Phase 6 N Preliminary Plat Application

Planning Board Meeting

PROPOSED REVISED CONDITIONS

Nicolas P. Robinson, Esq. on behalf of NNP-Briar Chapel, LLC

Lot Reforestation  
DATE: JUN 14, 2012  
DRAWN: RP, ED  
CHECKED: ED  
SHEET: L401

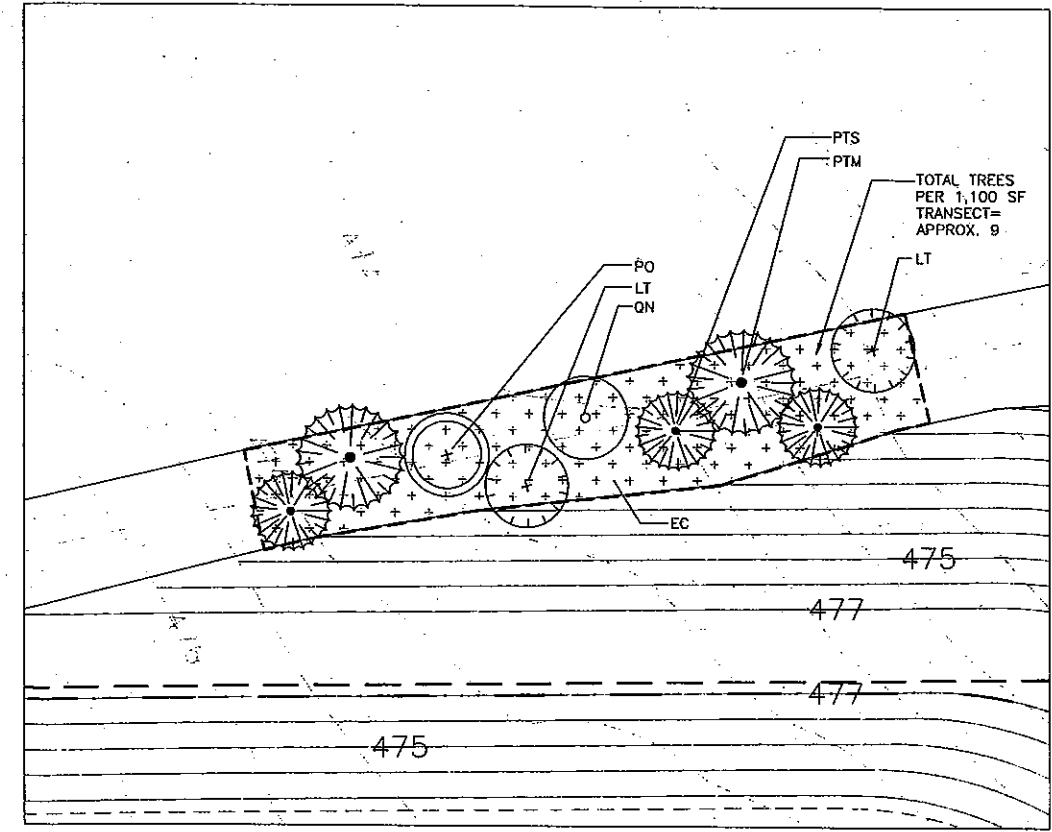
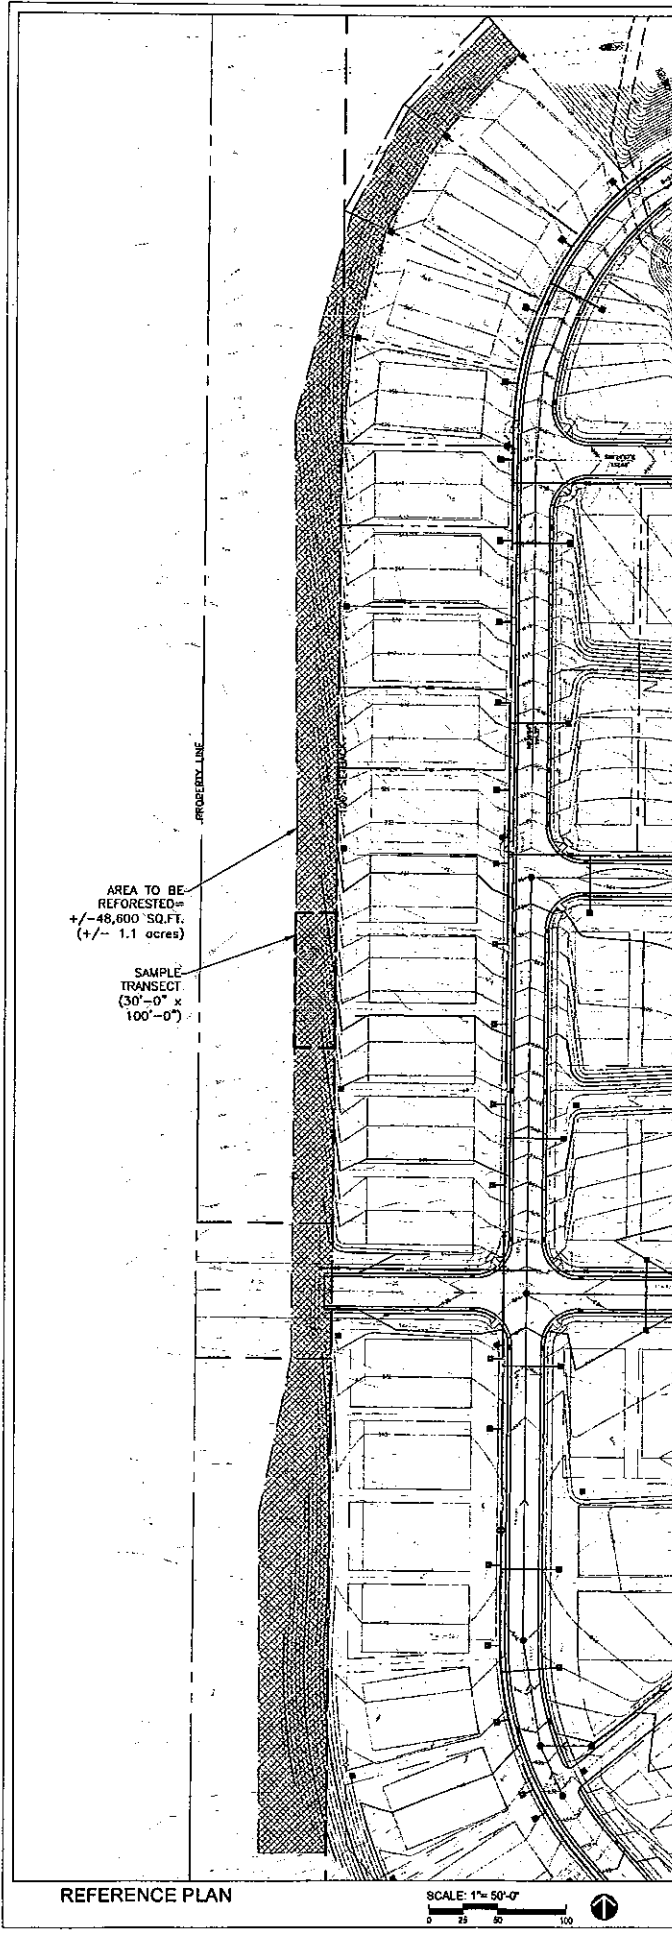
2. Prior to final plat submittal a The re-vegetation plan be submitted herewith by Applicant (and attached hereto) is approved and shall be installed during the first seasonally appropriate time following final plat approval for Phase 6 N. to staff for review and approval for those areas that require limited grading within the perimeter buffer.
